Würth Elektronik eiSos GmbH & Co. KG

## Product/Process Change Notice (PCN)

PCN #: WL-SMDC\_20171215

WL-SMDC 1503535xxx all products

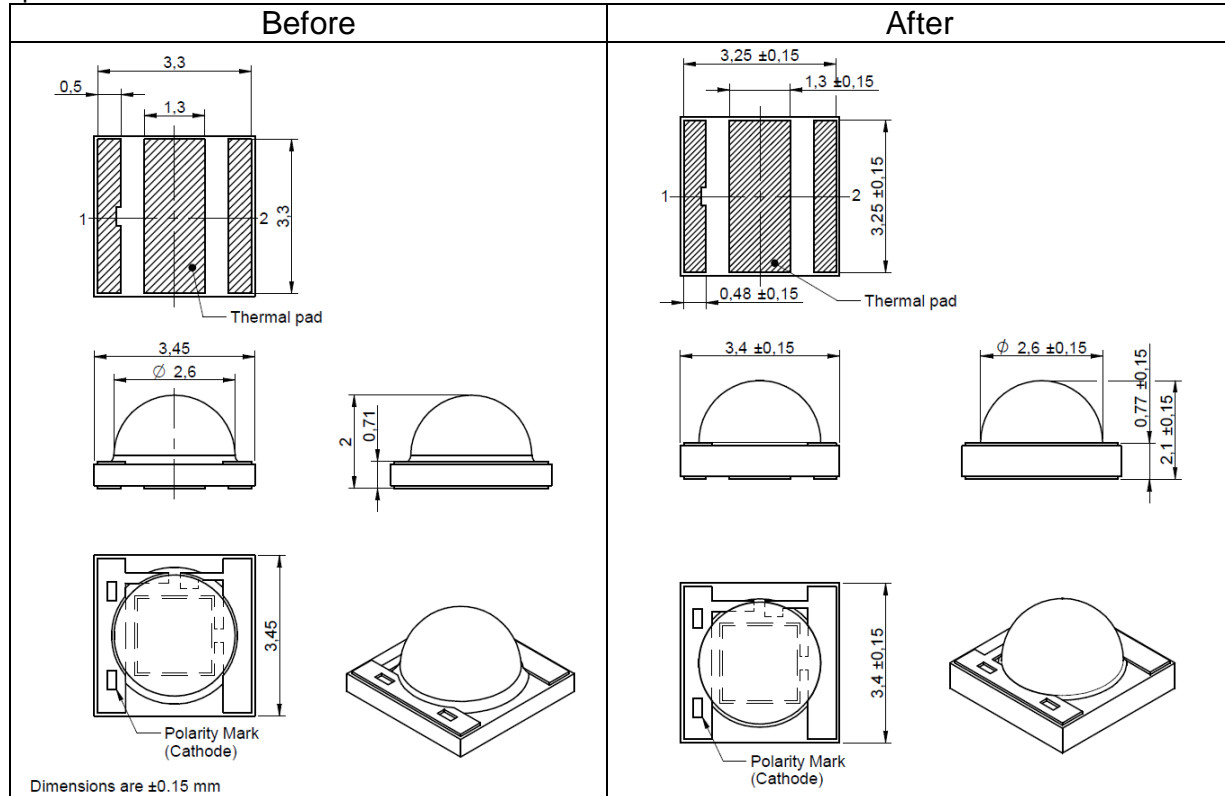
For process improvement purposes, Würth Elektronik will change the dimensions of the substrate for the WL-SMDC line products with 0.05mm

The substrate size will be the only change. The change will not affect the land pattern and soldering specification.
